VILLAGES OF DEER RIVER SUBDIVISION

APPLICATION NUMBER 7 DATE November 6, 2014

DETAIL SITE PLAN

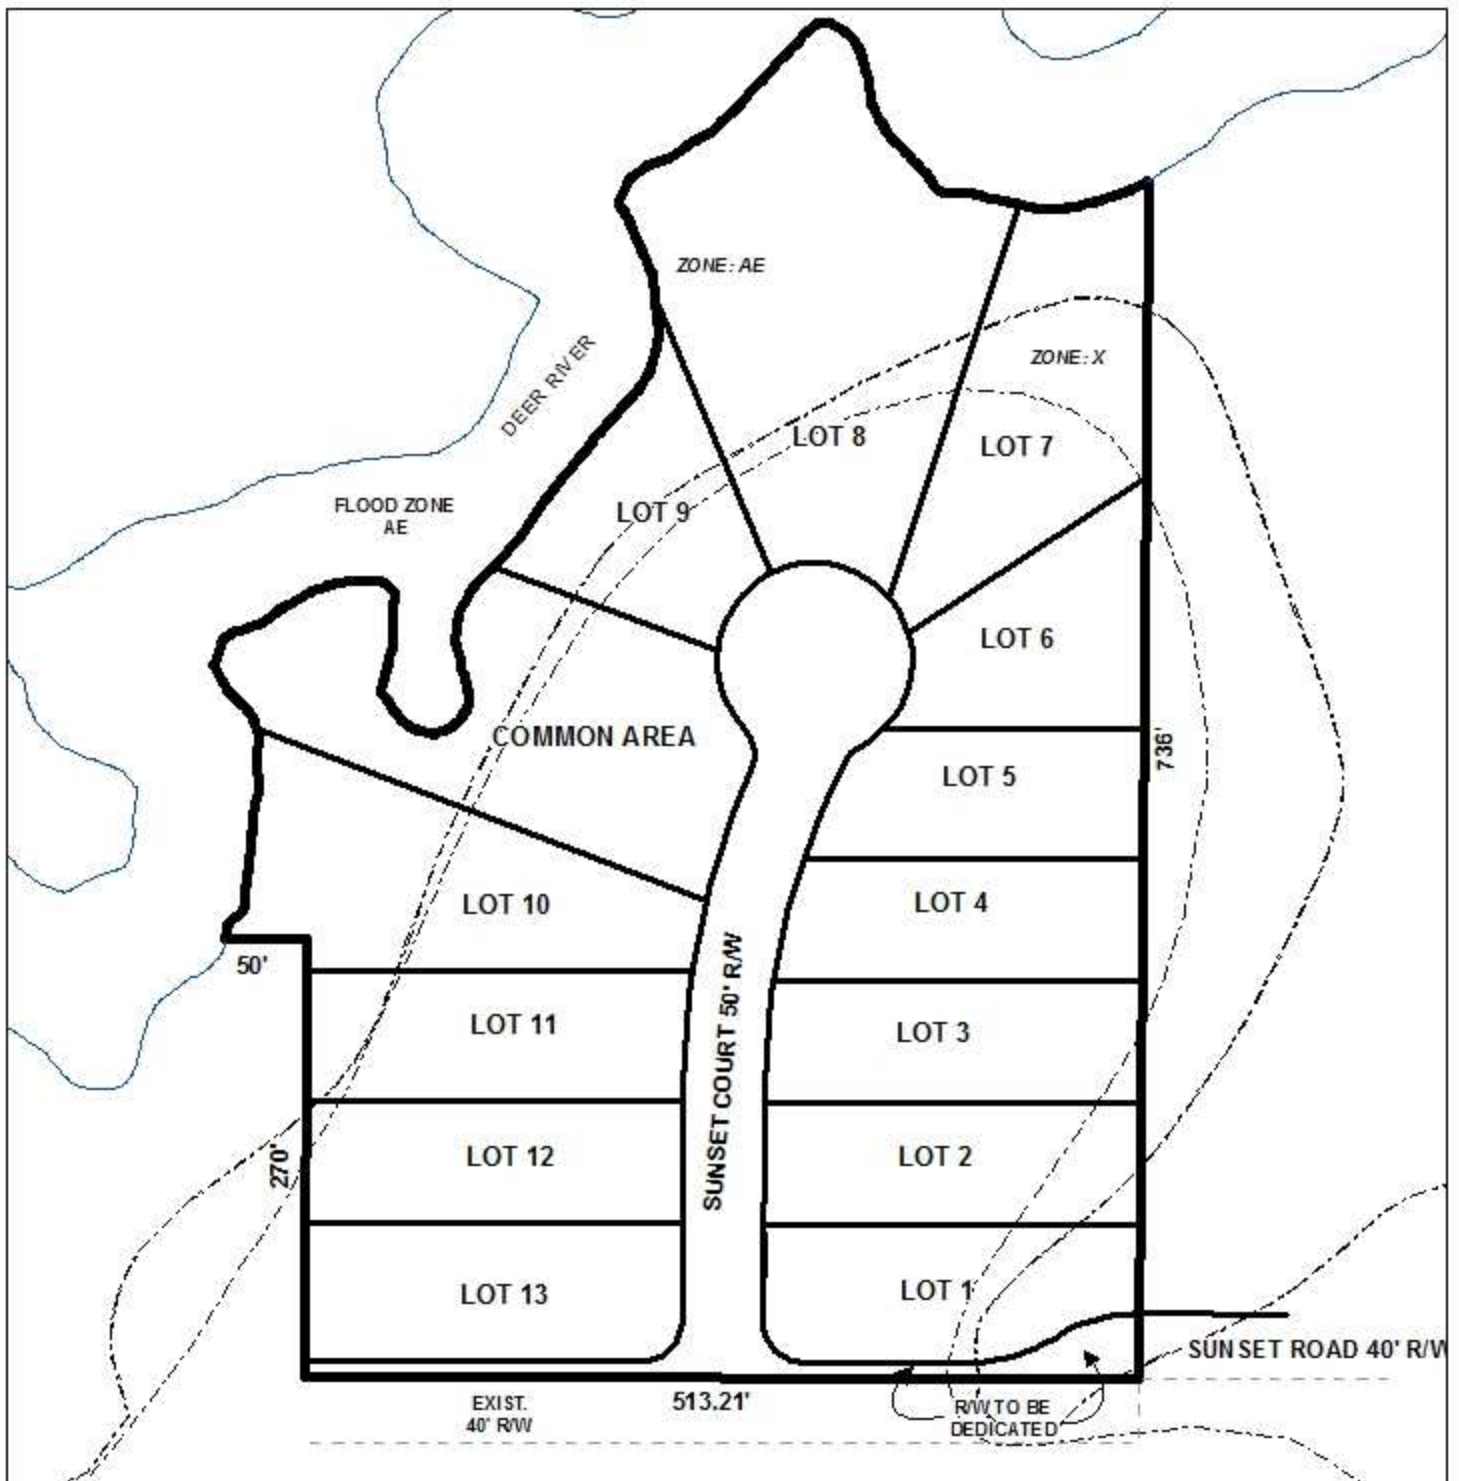
The lot sizes are labeled in both square feet and acres, and the proposed lots would exceed the minimum 15,000 square foot size requirements of Section V.D.2. of the Subdivision Regulations. It should be noted that the square footage provided for proposed Lots 3 and 6 does not appear to be accurate. The correct lot sizes should be placed in square feet and acres on the Final Plat, if approved.

The 25' minimum setback line is not illustrated as required by Section V.D.9. of the Subdivision Regulations. The setback should be illustrated along all frontages on the Final Plat, if approved.

The site fronts onto Sunset Road, an unpaved minor street, and is illustrated as having a 40' right-of-way. Mobile County Public Works records show that the road has a prescriptive right-of-way (right of way is the width of maintained right of way). The preliminary plat illustrates a 10' deep strip labeled as "right-of-way to be dedicated". Minor streets with no curb and gutter require a 60' right-of-way, and this dedication will provide 30' from the centerline of Sunset Road as required. This dedication should be retained on the Final Plat, if approved. A note should be placed on the Final Plat stating that no future subdivisions will be allowed until Sunset Road is brought up to Mobile County standards.

It should be noted that Sunset Road appears to be approximately 16 feet in width. As such, the creation of a 13-lot subdivision, 1,100 feet west by a narrow unpaved road from Dauphin Island Parkway, should not be encouraged at this time. If Sunset Road were to be paved in asphalt and,

at minimum, meet the road requirements of Section VIII.E.2.c. of the Subdivision Regulations, then the proposed access concerns would be substantially reduced.

The preliminary plat illustrates a proposed new road, referred to as “Sunset Court”. Sunset Court is illustrated as having a 50’ right-of-way, with a cul-de-sac proposed to have a turnaround diameter of 120’. A 50’ right-of-way is appropriate if Sunset Court will have curb and gutter, otherwise, a 60’ right-of-way should be provided.

As a mean of access management, a note should be placed on the Final Plat stating that each lot is limited to one curb cut to the proposed Sunset Court, and denied direct access to Sunset Road, with the size, design, and location of the curb cuts, to be approved by Mobile County Engineering and conform to AASHTO standards.

There is a common area shown on the preliminary plat. If approved, a note should be placed on the Final Plat stating that the maintenance of all common areas and detention facilities is the responsibility of the property owners and not Mobile County.
